**Re: Project, Permit No. M-1980-244;  
Third Adequacy Review, Amendment Application (AM-13) Response to Comments**

## THIRD ADEQUACY REVIEW COMMENTS AND RESPONSES

<b>Newmont Corporation</b>	
CRIPPLE CREEK & VICTOR			
<b>Cripple Creek and Victor Gold Mining Company</b>			
<b>Figure 1</b> <b>Layback sequence West Cresson</b>

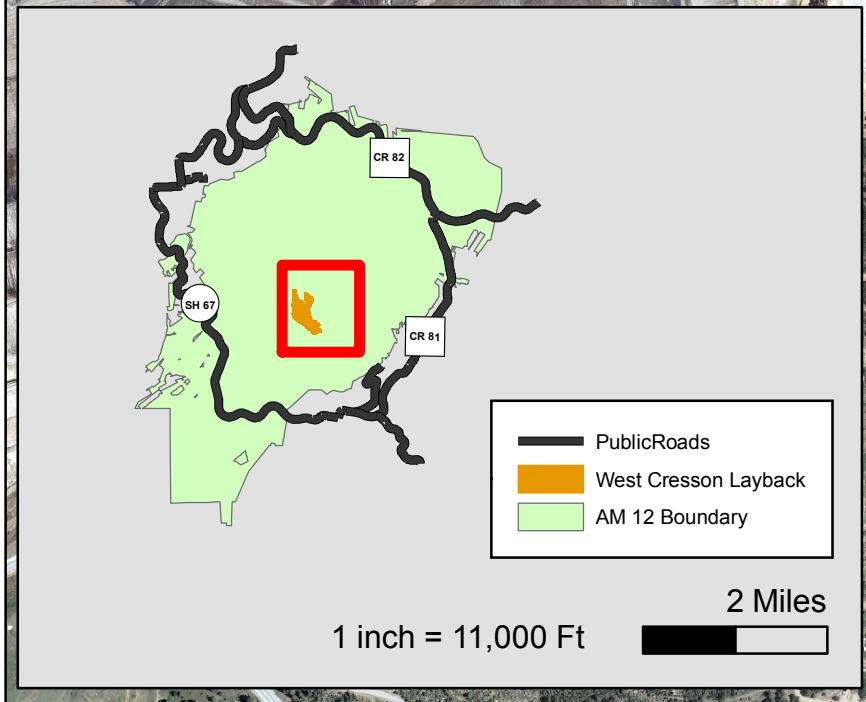
- b. Please provide a figure which shows where within the Main Cresson the layback will occur.*
- c. Did CC&V identify a geotechnical stability issue of the Main Cresson which warrants the layback?*

As discussed during a December 15, 2020 conference call between Newmont, the Division, and Geosyntec, the planned layback is purposed for the extraction of additional ore and production, not because of stability concerns as the Division suggested. Please see Figure 1, enclosed as Attachment 1, detailing the location where the layback will occur. Additional details regarding slope angle for mining laybacks is presented in Exhibit D – Mining Plan (previously submitted on August 3, 2020 as part of the response to the Division’s Preliminary Adequacy Review comments).

**Drawing C-3: Proposed Facilities - Buildings and Utilities  
Cresson Project - Amendment 13**

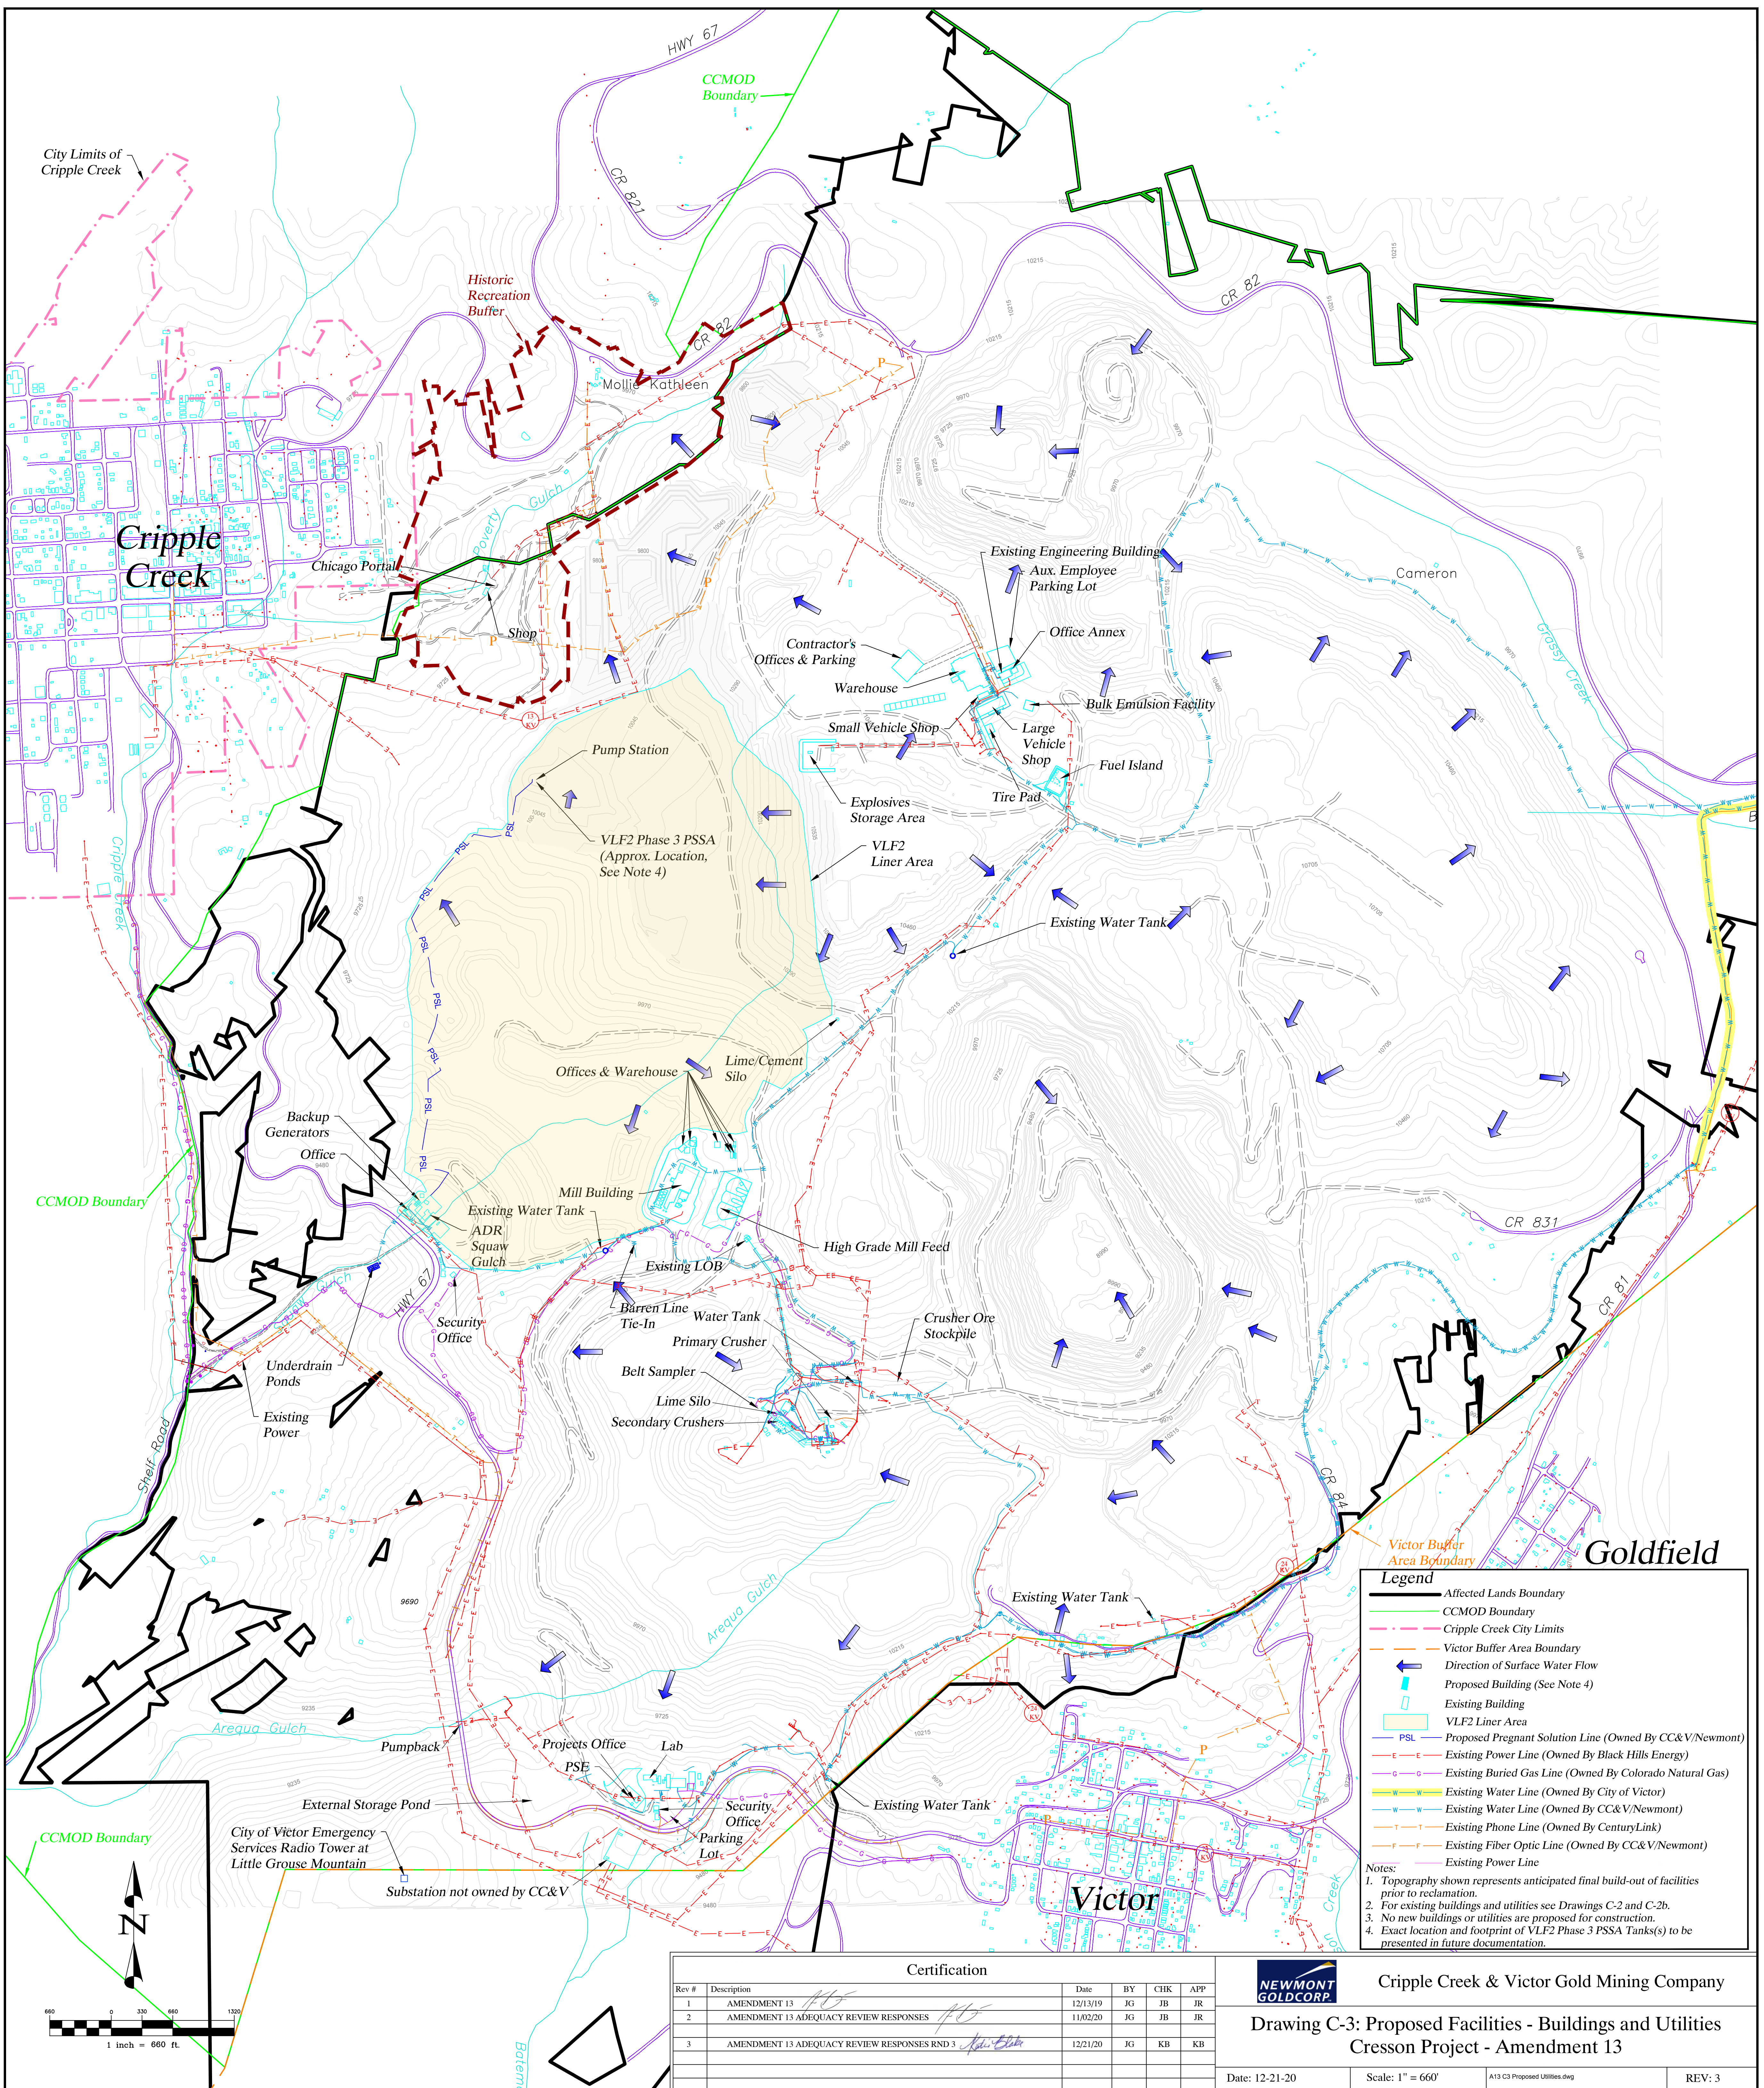
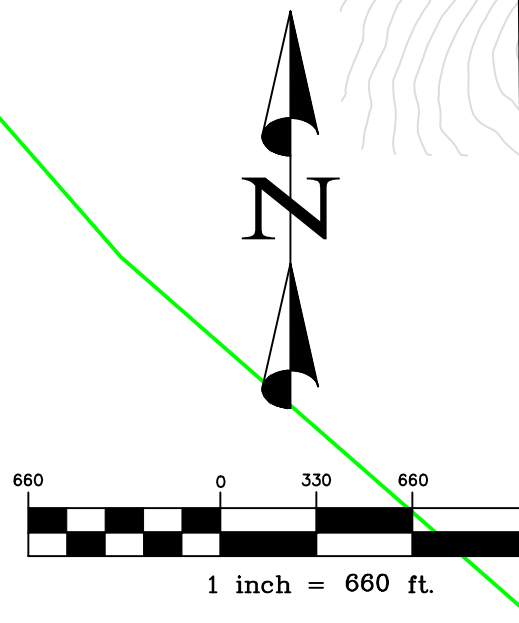
*30. The response requires additional clarification and possibly additional design work. This proposed VLF expansion extends process solution (both barren and pregnant) well beyond the current piping system. There appears to be several thousand feet of proposed process water pipeline not on liner. For these reasons, it is necessary to differentiate fresh water pipelines from process water pipelines on Drawing C-3 (or other drawings if appropriate) and show edge of liner for all existing and proposed VLFs. Pursuant to the redundancy requirement of Rule 6.4.21(7)(e), CC&V must provide a secondary containment design (such as a dual pipe) for all process water pipe not within the liner system. Segments longer than 500 feet and low sections must have means of determining if process solution has leaked from the primary pipe (such as sampling ports) and is then solely controlled by the secondary containment. Please note the secondary containment intent of this comment was originally stated in our 4/4/2020 letter. Please submit the following:*

- a. An Exhibit C drawing differentiating freshwater pipelines from process water pipelines and showing the extent of VLF liner (both existing and proposed) in such a manner as to demonstrate which process water pipelines require secondary containment.*
- b. Secondary containment designs for any process water pipelines proposed outside the existing or proposed VLF liner system.*

Drawing C-3 has been updated and is enclosed as Attachment 3. As discussed with DRMS representatives on December 16, the previous Drawing C-3 showed an outdated pipeline associated with the original design. The location of this pipeline has been revised and is shown on the updated drawing. The updated pipeline location is within the lined area.
